TOWN OF YARMOUTH
200 Main Street, Yarmouth, Maine 04096
www.yarmouth.me.us

Date: March 2, 2023
To: Chair Holden and Members of the Yarmouth Planning Board
From: Julie Dubovsky, Assistant Planner
Subject: Substantial Modification of a Structure in the Demolition Delay Overlay Zone and the Lower Village Historic District, Chapter 701, Article IX and X
George Cox and Heather MacNeil, Applicants, 5 High Street, Map 32 Lot 43

DETAIL OF PROPOSED FLOOR PLAN, FIRST FLOOR (A-100)

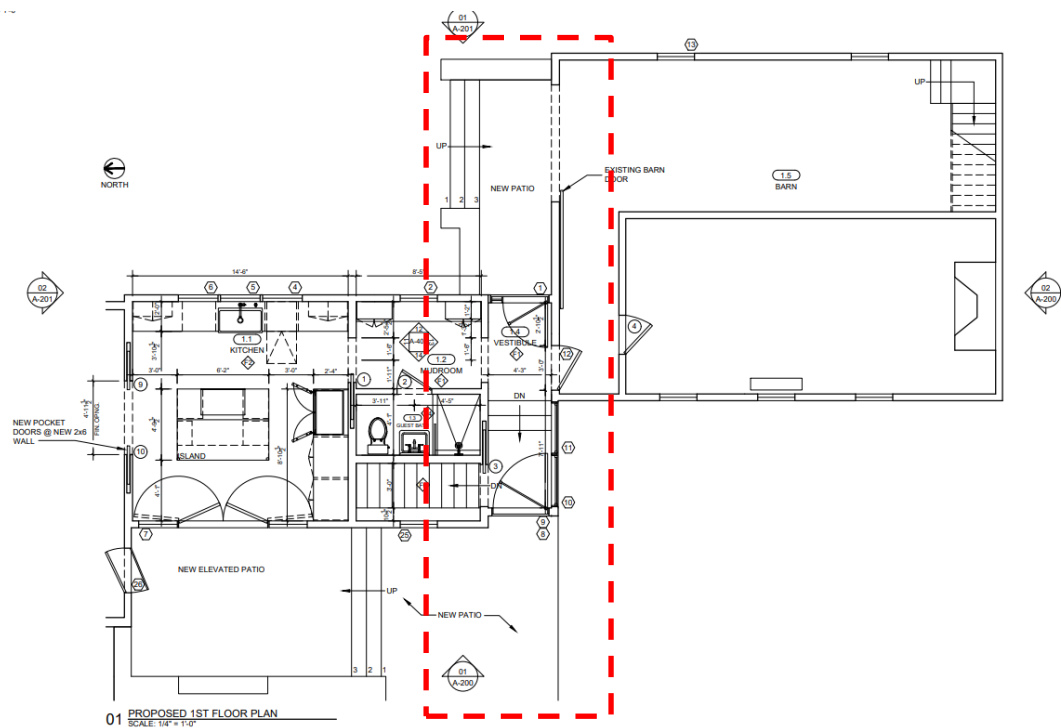
When viewing the house from the rear and to the west of the barn, the proposed new connection between the barn and house is also visible. The photograph to the right shows the existing southern wall of the main house, the covered deck between the main house and barn, and deck. It would be replaced with a vestibule addition that creates a conditioned corridor between the east (driveway) and west (backyard). The vestibule also provides access to the mudroom, barn, and relocated basement stair. Exterior walls are comprised of the vestibule are mostly glass (fixed windows on the south elevation and patio style glass doors at the east and west) and are illustrated on elevation drawings A-200 and A-201, and the proposed floor plan (drawing A-100) shown below.

**PROPOSED WEST FAÇADE
(A-200)**

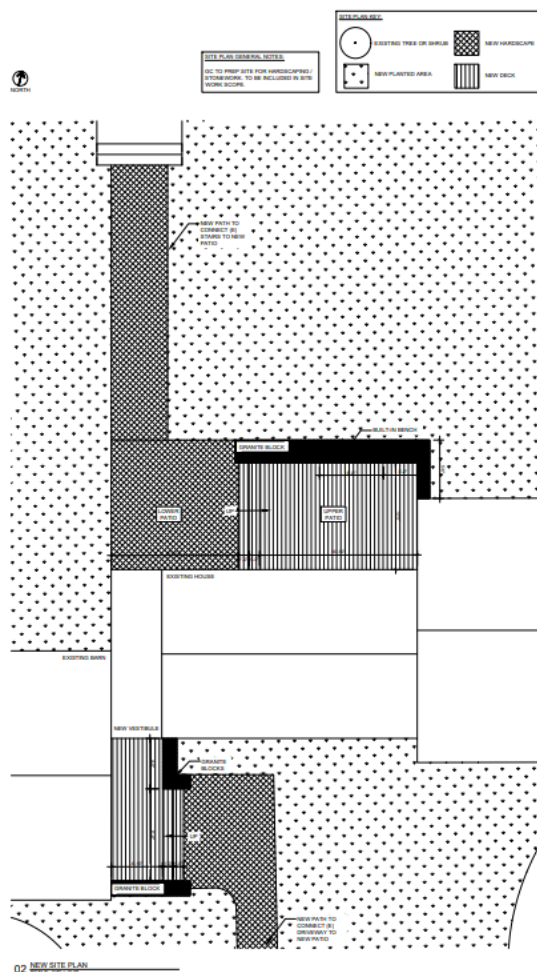
At the west side (see A-200 below), facing Portland St., they propose to change some of the fenestration locations to better suit the new interior layout of the home. It should be noted that none of the existing windows and doors in this area (circled in red) of the facade are original to the home. On the first floor, windows #18, #19, and #25 are the same size, while #7 represents a set of new glass French doors and sidelights. The doors open directly onto a new deck, which is to replace the existing deck. The applicants note that the existing deck is currently in a state of disrepair.

PROPOSED SITE PLAN

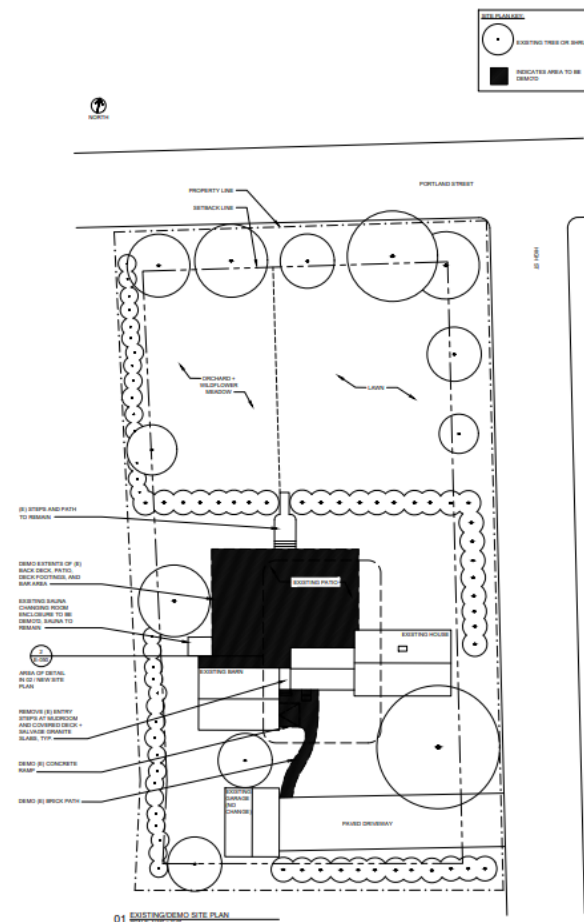
The site plan below depicts the existing and proposed deck on the western side of the home, shown in the new site plan as a Lower Patio and an Upper Patio. A new deck is also proposed in front of the barn and new vestibule; the existing concrete ramp will be removed here.
